ADDENDUM #1

Reference: Weber State University
Parking Lot W-9 Paving Improvements
DFCM Project No. 07083810

Subject: **Addendum No. 1**

BOLLARD

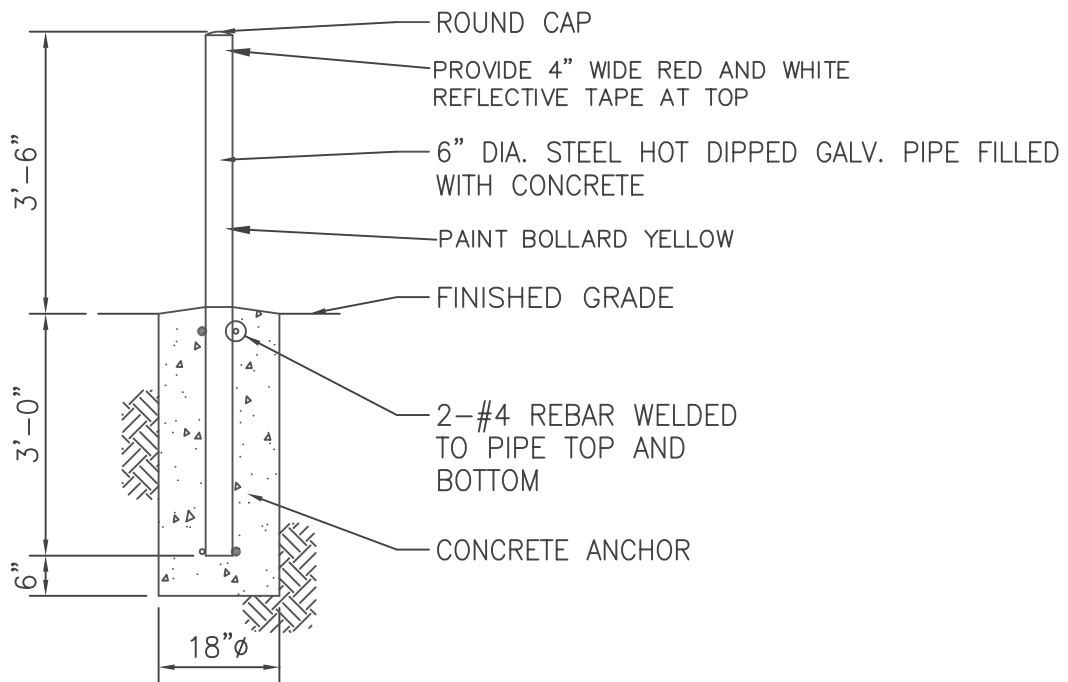
2. Furnish and Install 6 new bollards; 2 new bollards at existing utility riser and 4 around existing parking light. See accompanying detail.
